Certified Action of the City of Raleigh Planning Commission

Case File / Name: SP-48-14 / Union Bank at Strickland Road

Nature of Case: Proposed is an 8,342 square foot, two-story bank building on a 1.79 acre parcel and zoned Conditional Use, Office and Institutional-1 District. (Z-40-90/O&I-1)

Design Adjustment

Preliminary Site Plan

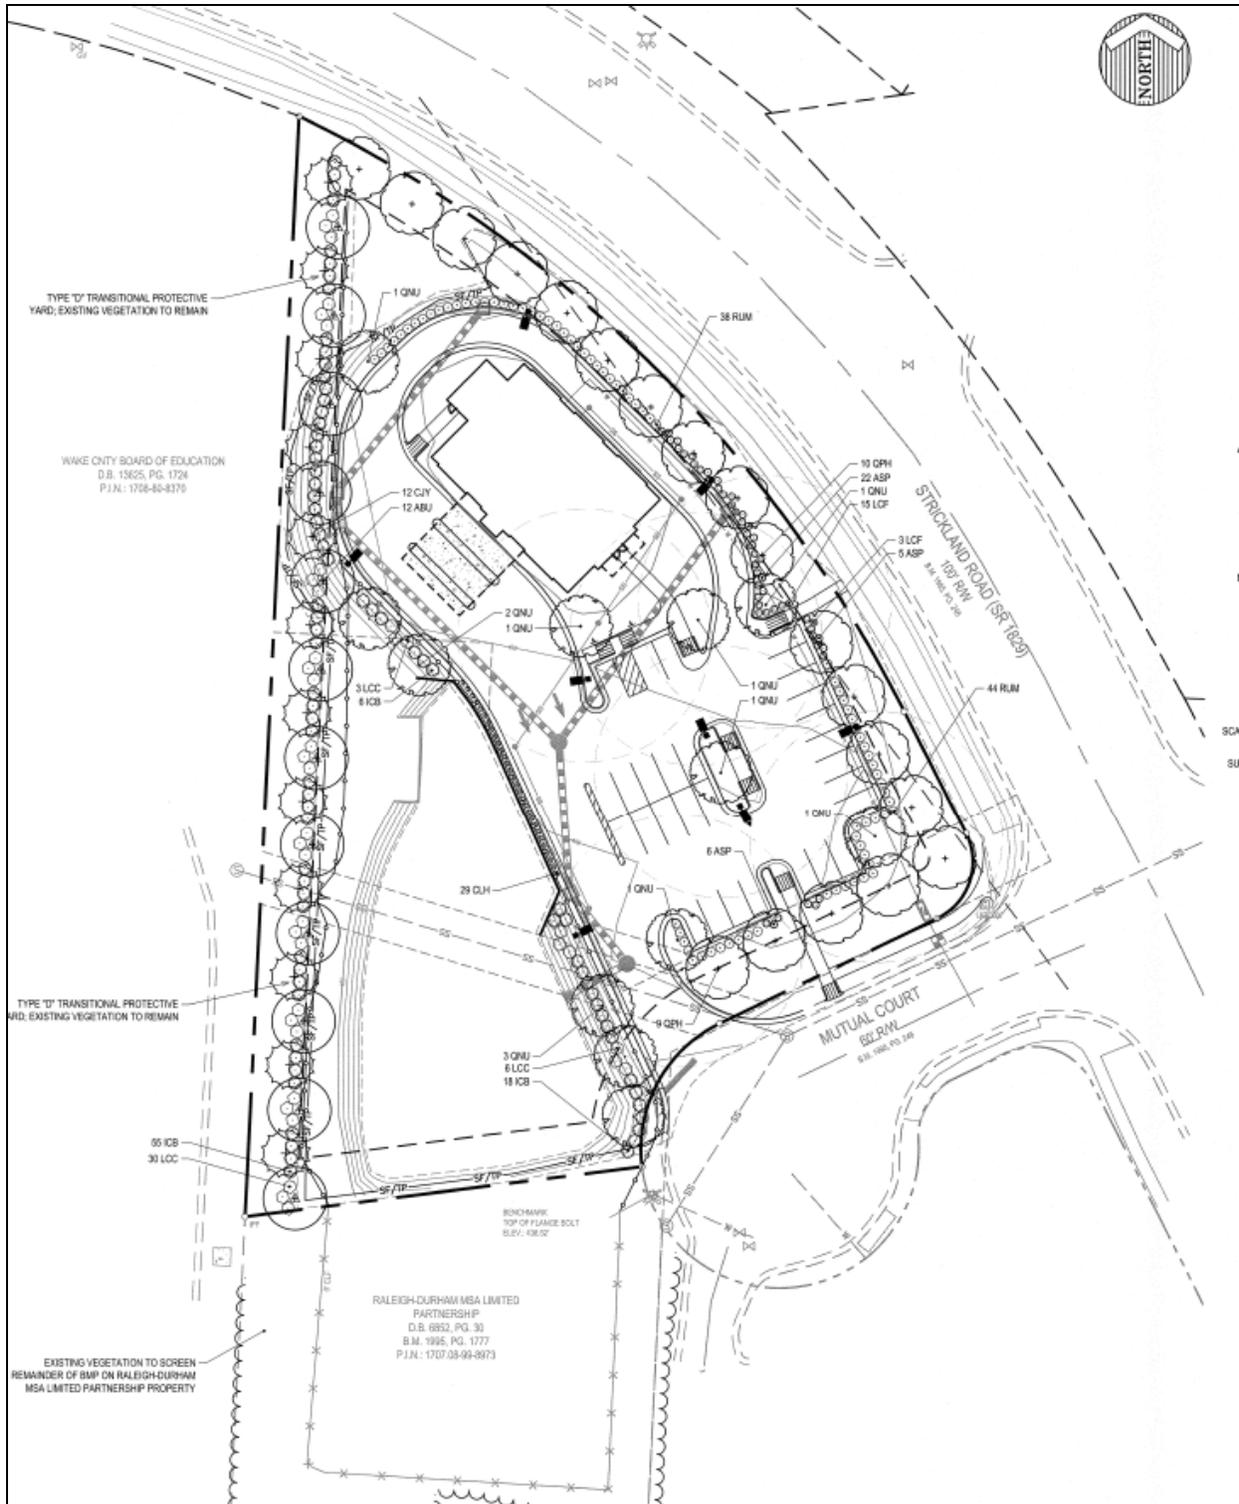
Key Issues: Plan does not include a 50' average width natural protective yard along Strickland Road (a thoroughfare) or a tree conservation area meeting code standards.

1. Due to existing Right of Way width, a Design Adjustment was granted allowing the sidewalk installation to occur adjacent to the back of curb along Mutual Court and following consultation with the NC Department of Transportation, required Street Trees are allowed outside of the Right of Way within a 30' planting area along Mutual Court and a 20' planting area along Strickland Road. (Section 8.5.1 D 4.)

Comment	Response
<ul style="list-style-type: none"> <i>The Commission recommends shifting the parking lot island that is part of the pedestrian pathway leading from Mutual Court to the business entrance to provide more direct and safe passage for pedestrians.</i> 	<p>A more direct route has been provided as requested.</p>
<ul style="list-style-type: none"> <i>The Commission recommends the addition of transparent windows or other articulation on and evergreen plantings in front of the north building elevation to screen and add visual interest to the predominantly blank wall that is visible from Strickland Road. The Commission does not recommend the use of faux fenestration, but instead recommends taking cues for articulation from the remaining elevations, and responding to the site lines from Strickland Road to the north elevation.</i> 	<p>A detailed evaluation will take place into making the north end of the building more aesthetically pleasing. More evergreen landscaping will be the possible solution, as this is the location of the exit stairs, making addition of transparent windows difficult.</p>

<ul style="list-style-type: none"> <i>The Commission suggests preservation of the existing trees along the Strickland Road frontage, to the extent possible.</i> 	<p>In order to develop the site with the existing stormwater facility, the site plan was pushed toward Strickland Road. Existing trees will be preserved as much as possible, and required yards have been provided along Strickland Road.</p>
<ul style="list-style-type: none"> <i>The Commission recommends limiting the use of stucco to the inset portions of the façade, and refining the material palette to include just one color of stucco. The Commission does recommend including a limited amount of stucco on</i> 	<p>We will revise the color palette to create more than a diverse palette. Additionally some of the stucco will be revised to brick.</p>

- *The Commission recommends thoughtful placement of the dumpster and a dumpster screen that is compatible with the main building materials.*
- *The Commission recommends a more diverse plant palette, and the use of more than one type of vine.*

Private trash collection will be utilized for this development, and a dumpster is not proposed with this development.

The plant species specified for this project have been specially chosen to meet the LDO requirements. A diverse species of plants have been chosen, as we also balanced keeping a fairly consistent feel for the project as well.
